Project	IEEE 802.16 Broadband Wireless Access Working Group < http://ieee802.org/16 >	
Title	Addressing the missing MAC functions in 16m Relay (Section 15.6)	
Date Submitted	2009-11-06	
Source(s)	Rakesh Taori, Jicheol Lee, Heewon Kang, Hoky Choi, Hyunjeong Kang, Jungshin Park, Jack Jang, Youngkyo Baek, Jung Je Son, MingXia Xu Samsung Electronics Company, 416, Maetan-3 dong, Yeongtong Gu Suwon, South Korea. 443-742.	Contact rakesh.taori@samsung.com jicheol.lee@samsung.com hkang@samsung.com
	Masato Okuda, Michiharu Nakamura, Keiichi Nakatsugawa Fujitsu	
Re:		
Abstract	This document analyzes the different solutions that are possible for relay. The document argues that whether a function should be located in the ARS or the ABS should be decided on the basis of performance (overhead, latency).	
Purpose		
Notice	<i>This document does not represent the agreed views of the IEEE 802.16 Working Group or any of its subgroups. It represents only the views of the participants listed in the "Source(s)" field above. It is offered as a basis for discussion. It is not binding on the contributor(s), who reserve(s) the right to add, amend or withdraw material contained herein.</i>

Addressing the mis

Figure xxx – Call flow for idle mode entry in the relay cell

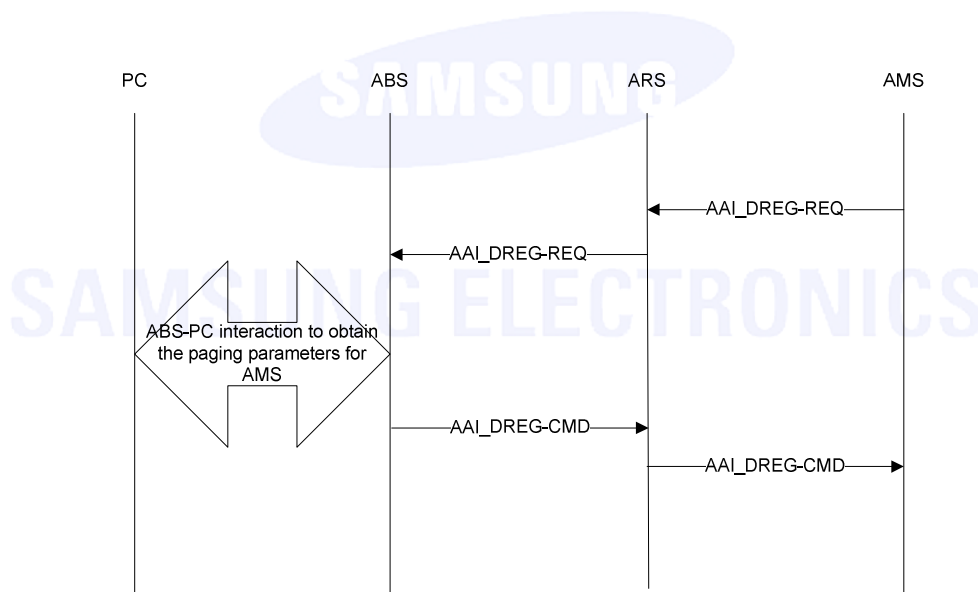
If the idle mode functions are managed at the ABS, the access ARS shall relay the AAI_DREG-REQ/CMD message between the ABS and the AMS. An operation of idle mode entry with an ARS involved is shown in Figure xxx.
